Access Compliance Report

Public Rights-of-Way

Intersection ID: N/A	Main Street: ALLEGIANCE DR	Cross Street: LADY LIBERTY LN	Location: SW
ADA ID: 16567E5B06DE	Ramp Type: Perp	Initial Pass/Fail: Fail	Overall Compliance: No
		Severity Score: 12.5

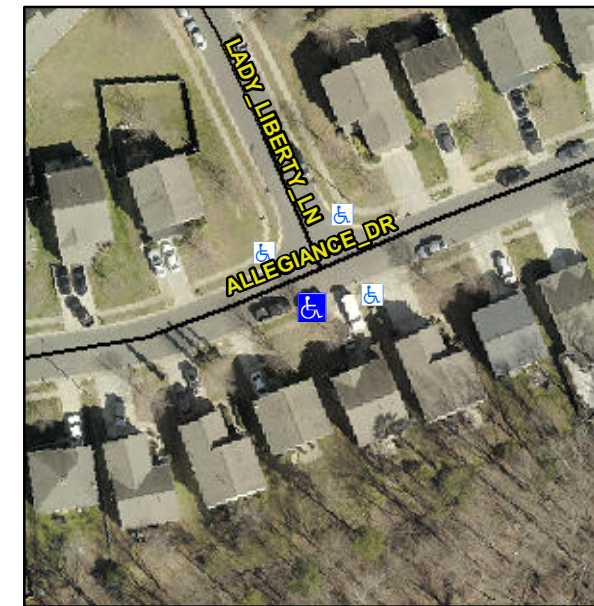
Not Found, R304.2.2

Compliance	Description	Data	Compliance	Description	Data
N/A	Ramp Length (in)	48.0	No	Ramp Slope (%)	8.7
Yes	Ramp Width (in)	52.5	Yes	Ramp XSlope (%)	2.0
N/A	Flare Type LT	N/A	N/A	Flare Type RT	N/A
N/A	Flare Slope LT (%)	N/A	N/A	Flare Slope RT (%)	N/A
N/A	Flare Traversable LT?	No	N/A	Flare Traversable RT?	No
N/A	Landing Length (in)	N/A	N/A	DWS Provided?	N/A
N/A	Landing Width (in)	N/A	N/A	DWS Contrast?	N/A
N/A	Landing Slope (%)	N/A	N/A	DWS Length (in)	N/A
N/A	Landing X Slope (%)	N/A	N/A	DWS Full Width?	N/A
N/A	Landing Curb? (Y/N)	N/A	N/A	DWS Offset (in)	N/A
N/A	Shared Landing?	N/A			
N/A	Gutter Ponding?	N/A	N/A	Gutter Slope (%)	N/A
N/A	Gutter Lip Ht (in)	N/A	N/A	Gutter X Slope (%)	N/A
N/A	Painted X Walk1?	No	N/A	Painted X Walk2?	N/A
	X Walk 1 Direction	To N		X Walk 2 Direction	N/A
N/A	X Walk 1 Width (in)	N/A	N/A	X Walk 2 Width (in)	N/A
	X Walk 1 Slope (%)	5.5		X Walk 2 Slope (%)	N/A
	X Walk 1 X Slope (%)	0.1		X Walk 2 X Slope (%)	N/A

Remove & Replace Entire Ramp.
